Update to ESS Moderators, version 15/9/2016

To be lodged in CHESS as follows:

An update has taken place to the ESS moderator-reflector baseline [1], resulting in a change in the source brightness and viewable width. The main change is a move from the "butterfly 2" to the "butterfly 1" geometry, as sketched in Fig. 1 below. The change is applied equally to the top and bottom moderator assemblies.

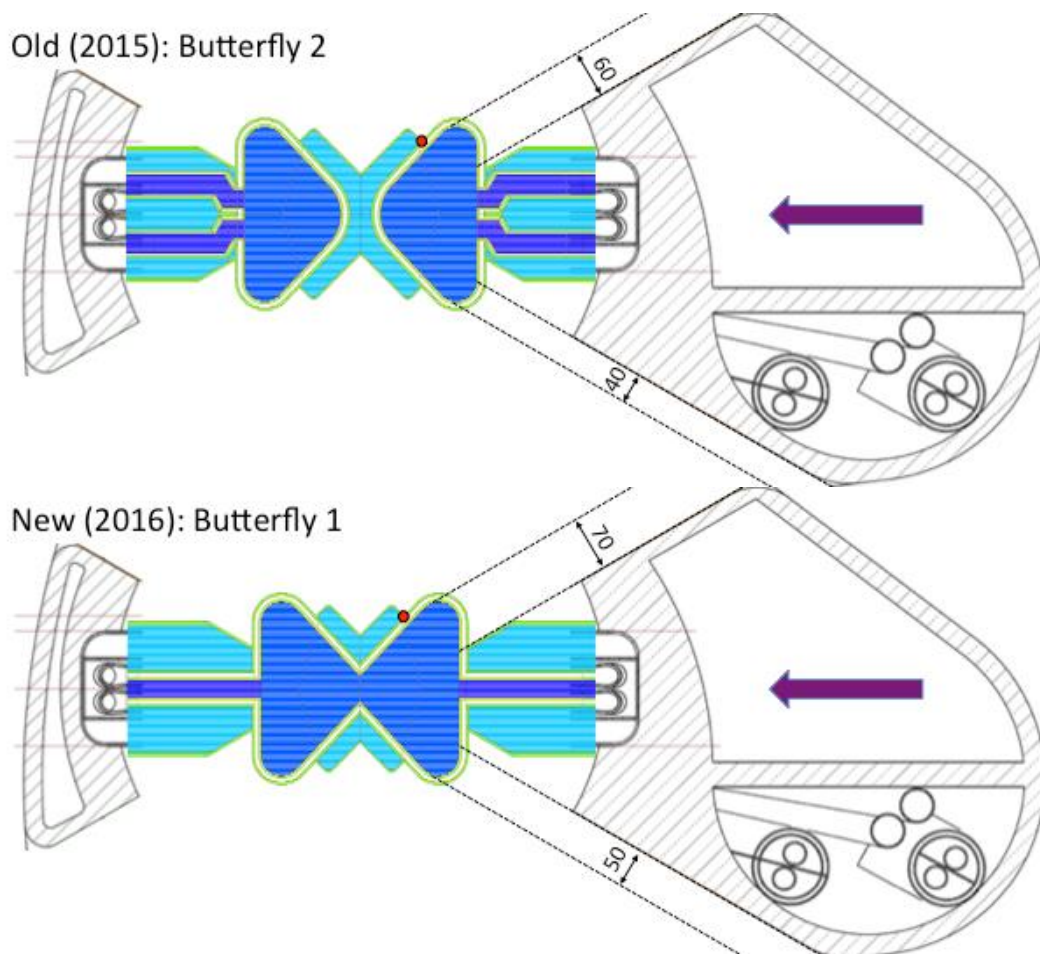
There are a number of motivations for this change:

- The balance of the viewed width of the thermal (up to 140 mm) and cold (60-80 mm) was skewed to the detriment of the cold moderators

- The 4 edge beamlines (at 30° and 120° to the proton beam) were limited by structures in the monolith that will not be changed during the lifetime of the facility
- The footprint of the moderator assembly was too large compared with the neutron production hotspot in the target
- Many thermal instruments had difficulty in viewing the central, most intense part of the thermal moderator, due to its large distance (73 mm along the proton beam) from the moderator focal points.
- Instruments near the edges of the sectors will benefit from an increase in cold brightness, due to the increased projected depth of para-H₂ at those angles.

The details of the geometry and neutronics calculations are given in [2]. In order to minimise the impact on the neutron optical design of the instruments, the change of moderator design is associated with a change of the beamline origins (the “focal points”) of the instrument beamports. Each focal point has been translated by 21 mm along the direction of the proton beam, towards the target centre. The new focal points are thus at (54mm, 89mm) [3]. For most instruments, the change of moderator geometry thus has no impact on the beam optics.

Fig. 2 Projected full width of moderators for all beamports from [2]. The angle runs in a counter-clockwise direction with zero pointing along the proton beam, such that the beamports are shown starting with S1 and ending with W1.

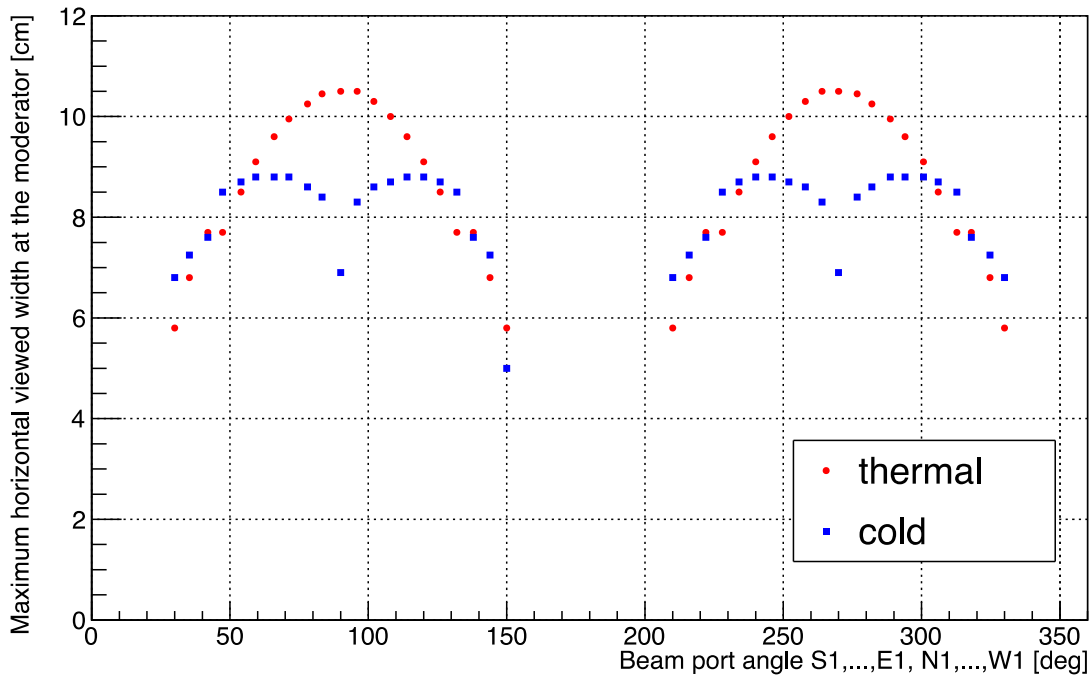
The main impact on the instruments of the geometry change, and a key motivation in making the change, is in the projected widths of the cold and thermal sources, which are shown in Fig. 2 below, as a function of beamport angle.

As can be seen in Fig. 2, the angular variation of the projected width of the moderators is now much better matched between the cold and thermal moderators; the cold widths have increased by about 1 cm, while the thermal widths have decreased by about 2.5 cm, resulting in cold and thermal widths which are much more similar than before. The increase in the width of the cold moderator is

important, since cold instruments generally can use more phase space than thermal instruments, due to the greater angular acceptance of neutron guides for cold neutrons.

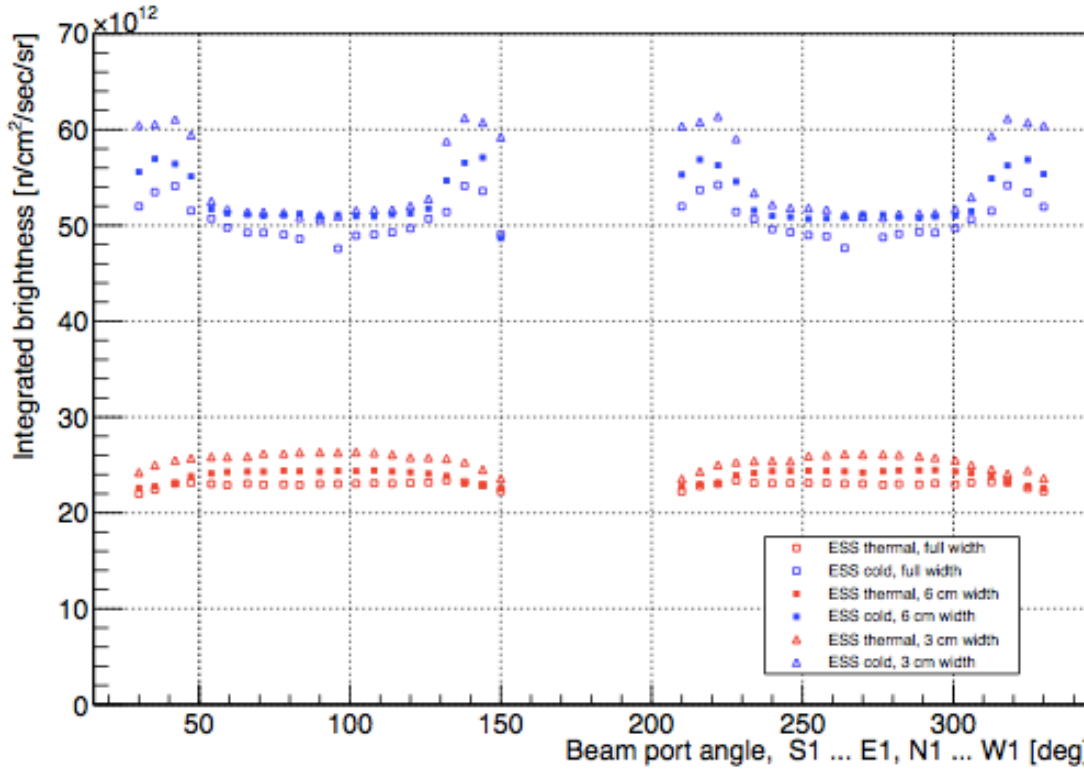
The angular dependence of the brightness of the top (3 cm) moderator is shown in Fig. 3 below

The brightness numbers have overall decreased by about 30% for the thermal moderators and 20% for the cold moderators, compared to ref. [1]. This is due to the transition from a physics model to an engineering model used in the calculations, performed in parallel to the evolving engineering design of the target station. A detailed modelling of the target-moderator-reflector assembly according to the engineering design of the moderators and reflectors was performed. Design changes in the target, which impacted on the brightness, were also incorporated, such as the reduction of the effective density of tungsten in the target, in order to ensure good flow of the helium gas coolant, and the increased distance between the target wheel and pre-moderators, for safe operation of the target. A full description of the MCNP model can be found in Ref. [2].

Another effect to take into account, is that the brightness numbers for the thermal source shown in Fig. 3 are now defined for a more realistic source width than before. The previous brightness numbers tended to overstate the thermal brightness by

including the central, most intense part of the thermal, which is often not accessible, due to its distance from the beamport focal point.
